STRENGTHENING OF ESSENTIAL OIL INDUSTRY IN KOREA

DP/DRK/88/001

Technical report: Part one, findings and recommendations\*

Based on the work of Mr. Siegfried Langner, UNIDO consultant

Essential Oils UNIT-- DIKK
Site plan
Drawing number 0124.00 - (00.110)
Made on 1.8.57 - 11.57
Made by I. A. V. Pr. B. K. K. (A)
Controlled by: P. E. G. C. M. (A)

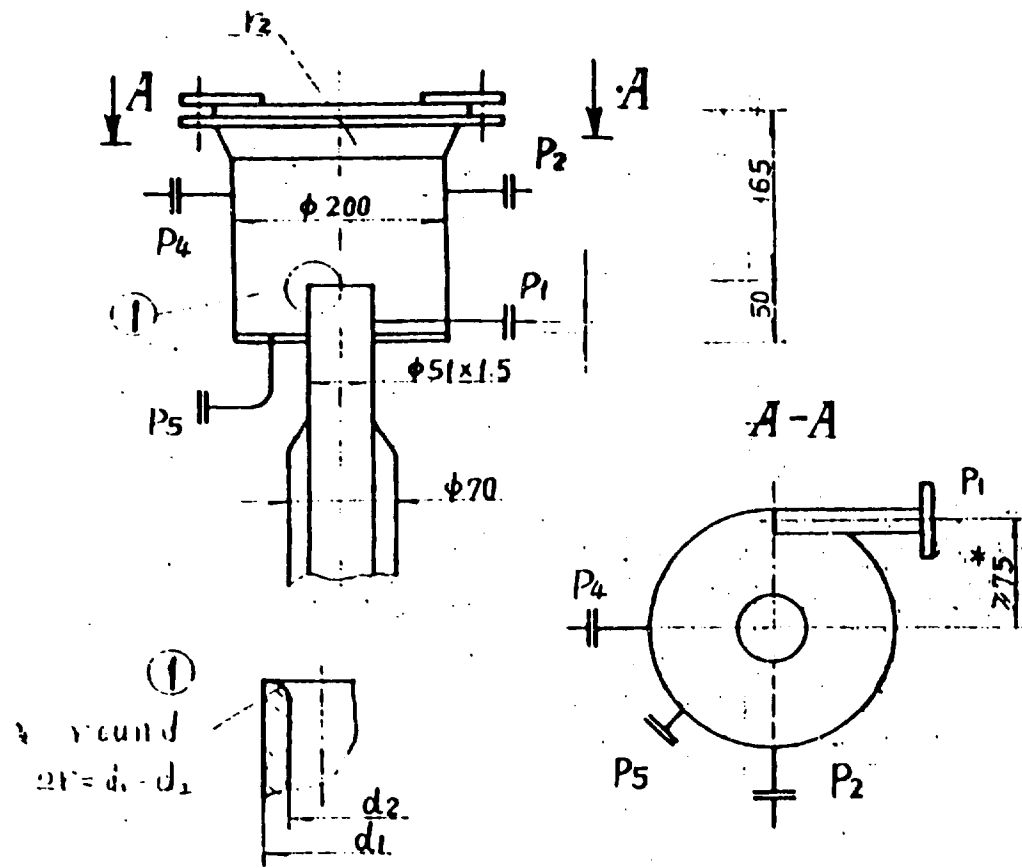
The most favourable place "the Plant Site" for the installation of the pilot equipment is at the north side of the laboratory building of PEORC (see annex 3, layout, drawing No. 0134.00 - 00.1(2)). The necessary surface is available at this place. There already exists a technical shed with the machine room and the most important power connections (electricity, cooling water).

1. The site plan, drawing number 0134.00-00.1(2), is the basis for the contract talks, the following projecting by the GDR-side and the activities by the DPRK-side.
